**STORE PROPERTY INVESTMENTS LTD
LAND WEST OF BROOK LANE AND
SOUTH OF A259
RUSTINGTON**

**ROAD SAFETY AUDIT RESPONSE
REPORT
STAGE 1 - ROAD SAFETY AUDIT**

JUNE 2018

scale	1:500@A3	drawn by	OAN	checked by	VL
date	JUNE 2018	cad file	Master 2018-06-06.DWG		
drawing number	SPRUST(BROOK LANE).1/10				rev.
					B

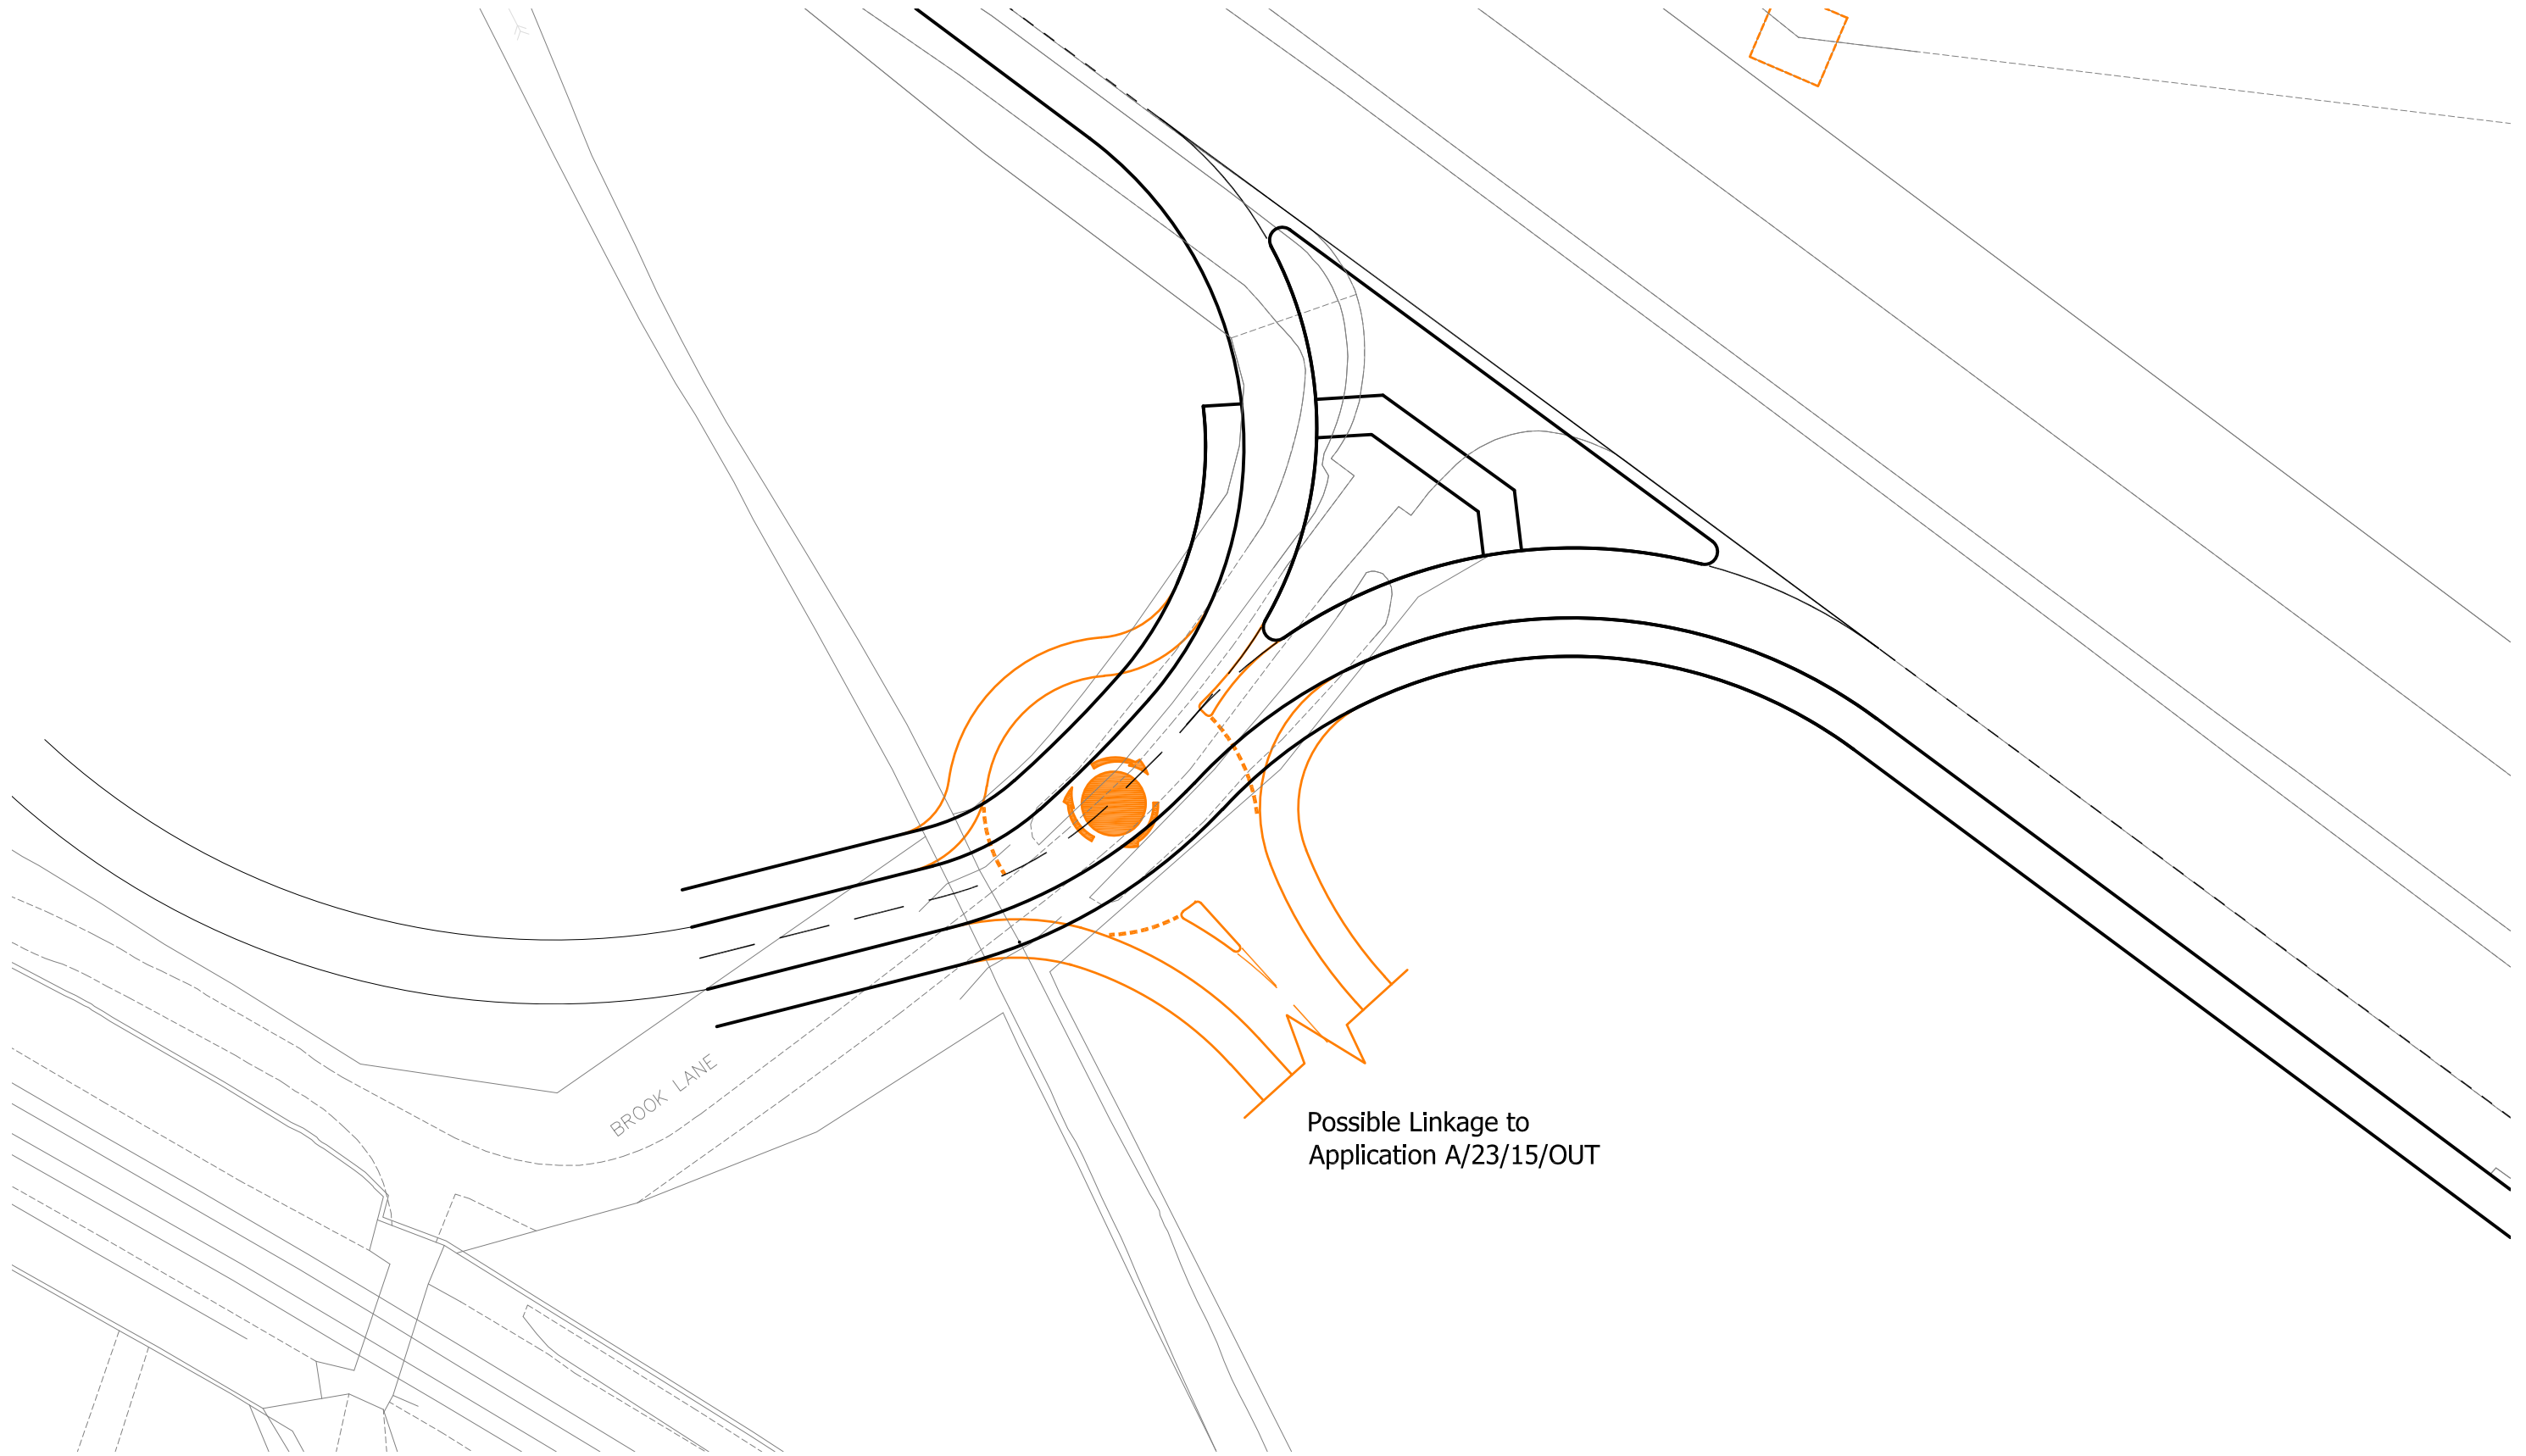
The westbound approach on the A259 to the proposed junction is provided with a margin (circa 1 metre), is delineated by a solid white line. The proposed northern kerb line of the proposed traffic island does not benefit from a margin. This could result in vehicles striking the kerb and subsequently losing control.

Offset the northern kerb line southwards to provide an appropriate margin.

This is agreed, drawing SPRUST(BROOKLANE).1/10B included at **Appendix D** shows a revised kerb line to include a 1m margin.

title
16.5m FTA ARTICULATED VEHICLE
ENTERING/EXITING ADJACENT SITE

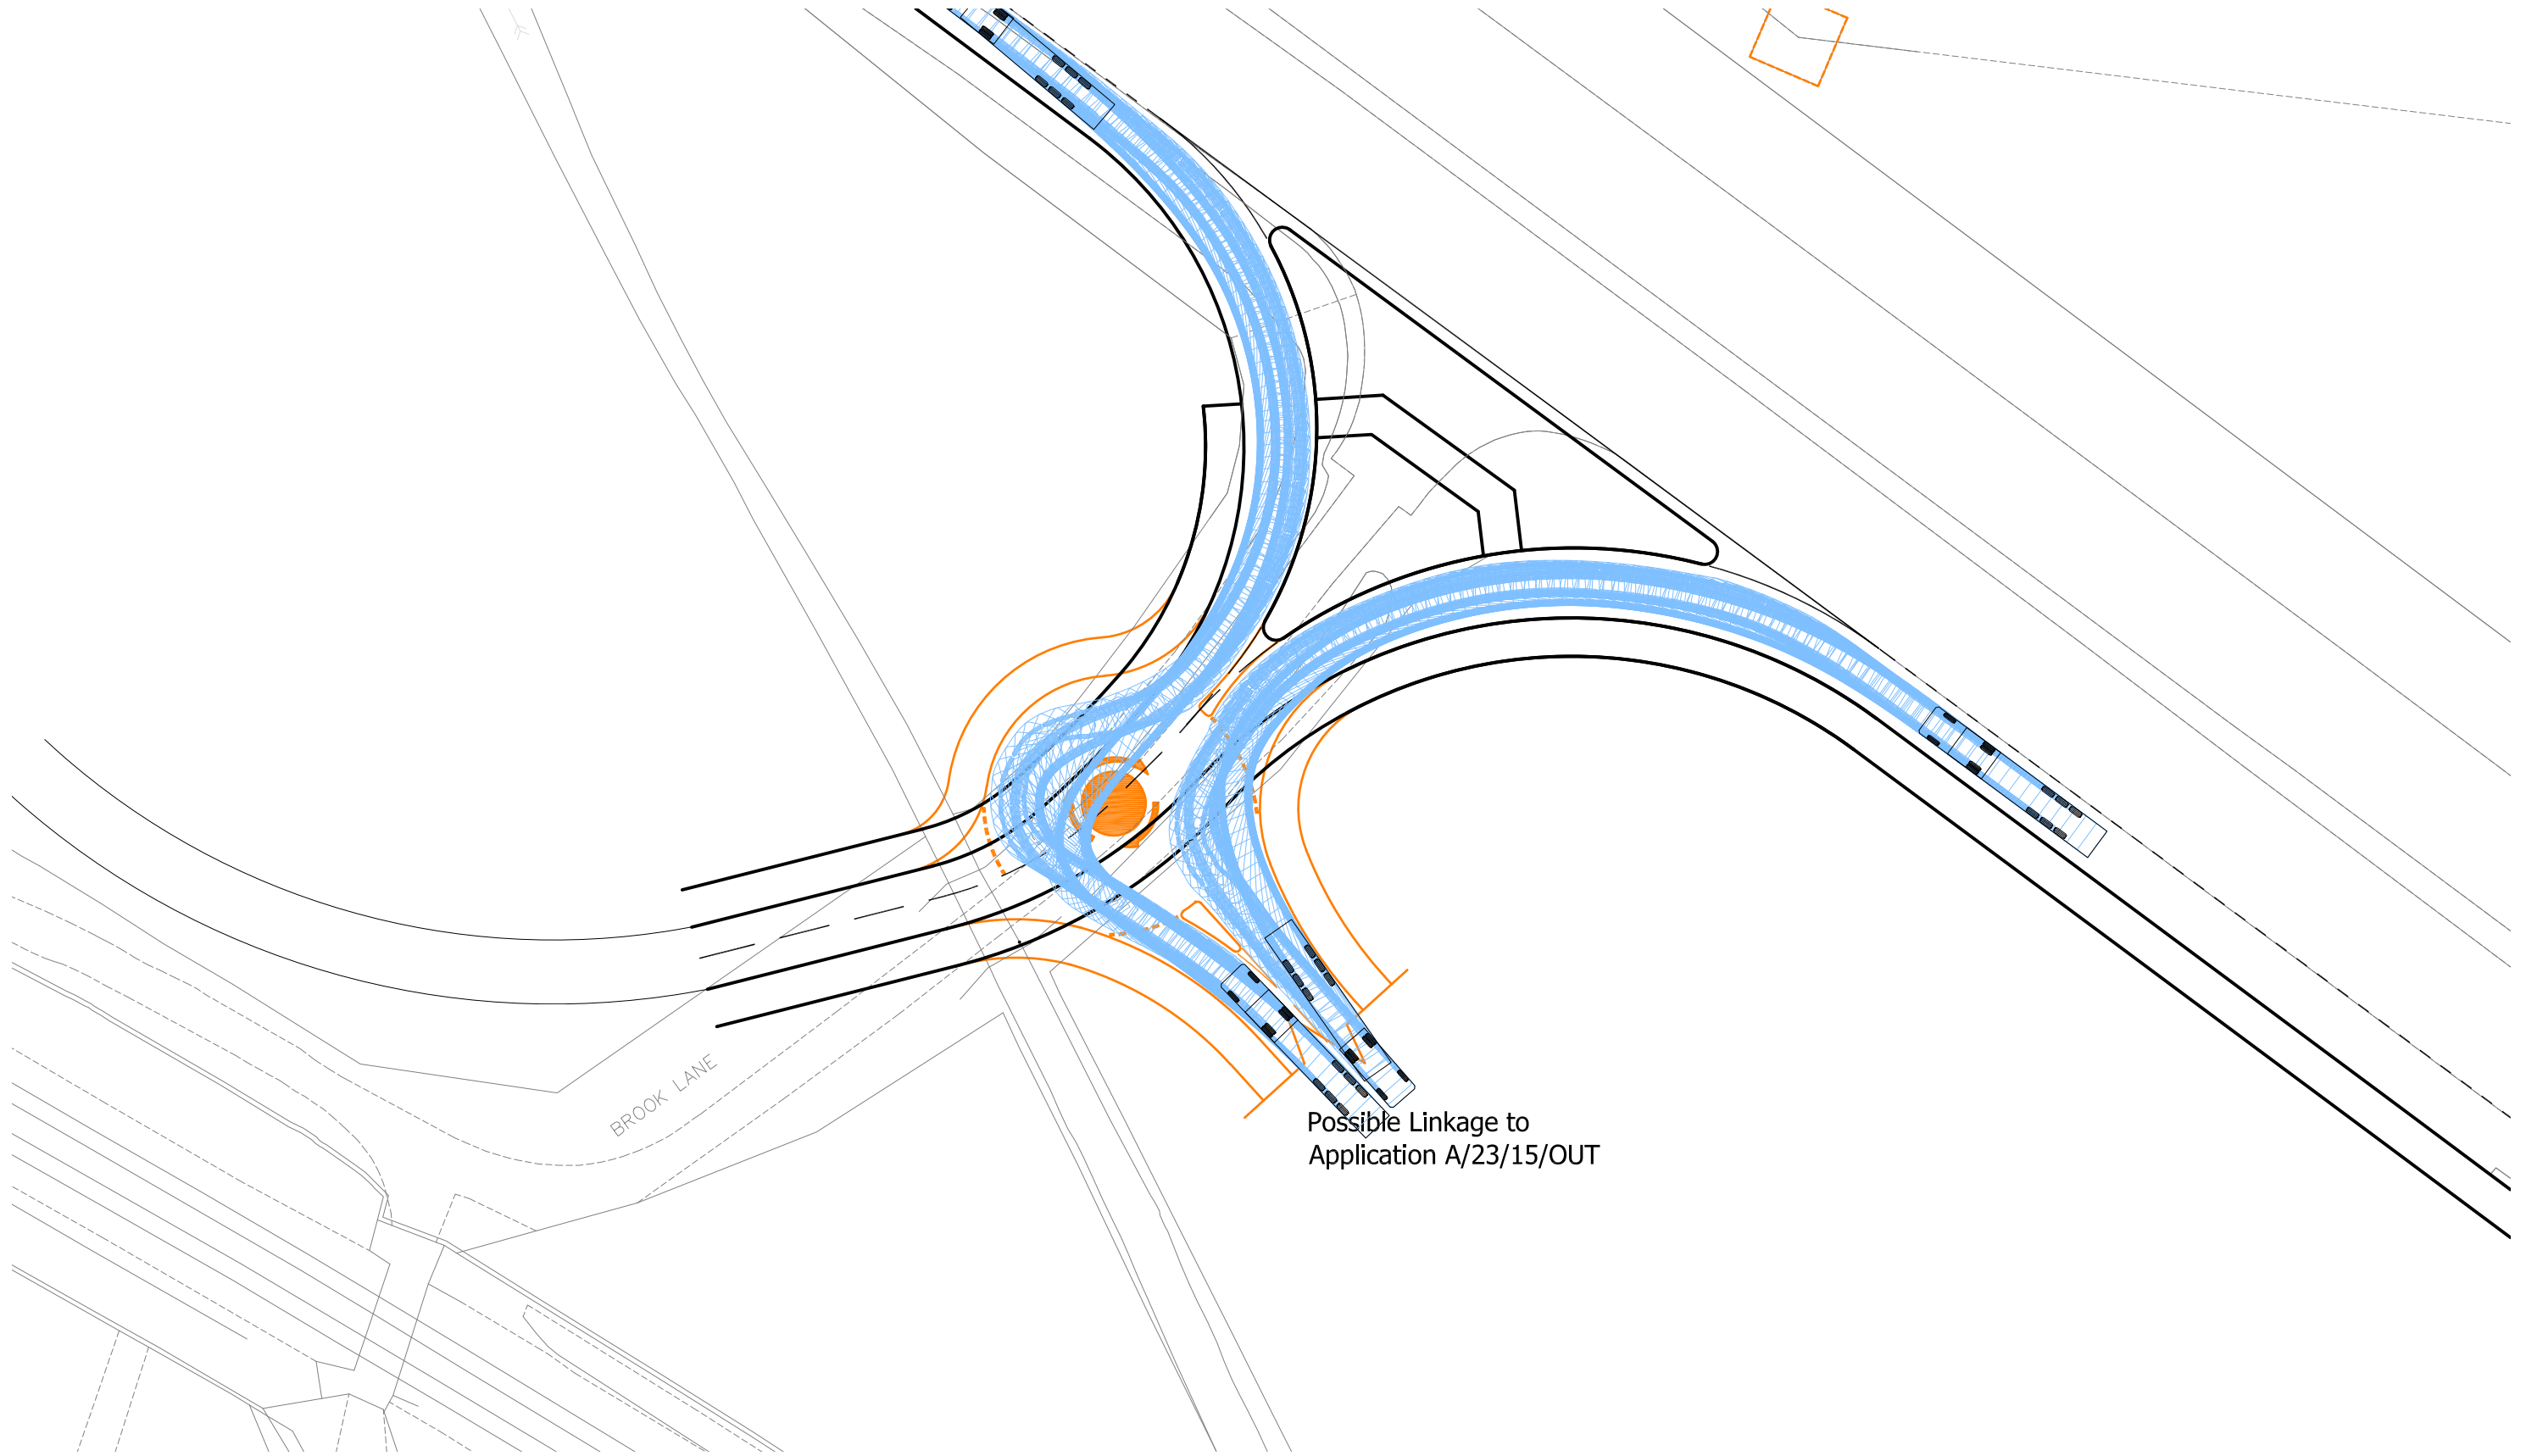
Details of swept paths have not been provided. It is important that all anticipated vehicles can access the site appropriately without traversing the footway or requiring excessive reversing manoeuvres.

Undertake swept path analysis using anticipated vehicles to ensure that the vehicles can access the site appropriately.

This is agreed, swept path plots of both a single deck bus and a 16.5m articulated vehicle are included at **Appendix C**. The swept path plots demonstrate that both vehicles can enter and exit the roundabout from all directions.
